# Technical Service Information

## THM 4L60 (700-R4) LOSS OF LINE BOOST AT WOT

Figure 1

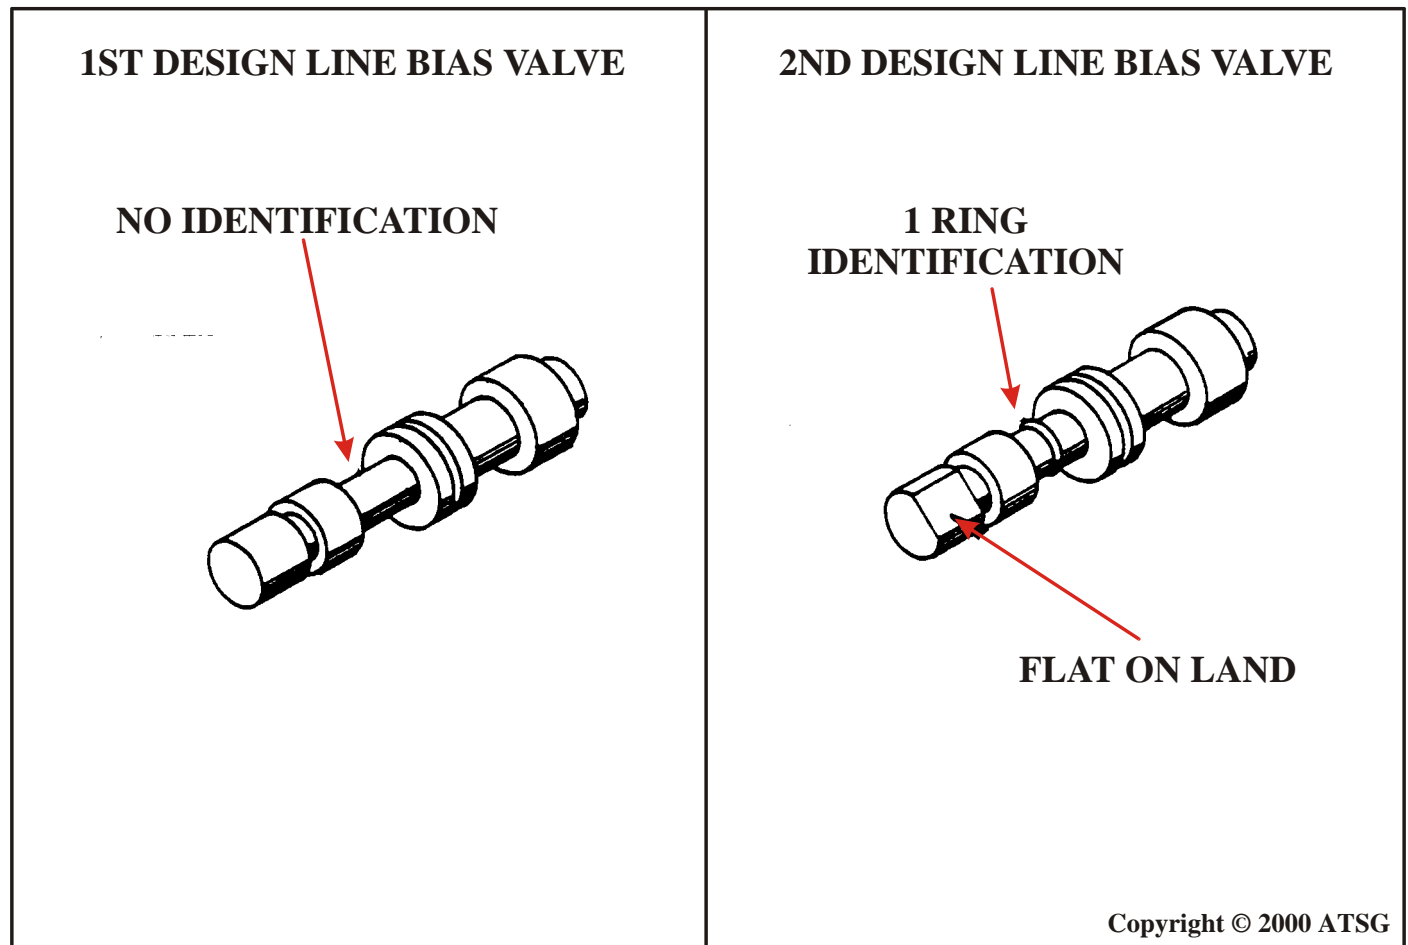
The cause may be a mis-matched line bias valve, and spacer plate. Beginning in 1987, a 2nd

**CORRECTION:** design line bias valve was introduced that has a "Flat" on the small land (See Figure 1). This change required that the detent hole in the spacer plate be eliminated (See Figure 2).

If the 2nd design line bias valve (With **Flat**) is installed with the 1st design spacer plate (With Detent Hole), all T.V. oil will be exhausted at full throttle positions.

Install matching line bias valve and spacer plate.

Line bias valve **WITHOUT** flat, requires spacer plate **WITH** detent hole. (Refer to Figures 1 and 2).

Line bias valve **WITH** flat, requires spacer plate **WITHOUT** detent hole. (Refer to Figures 1 and 2).
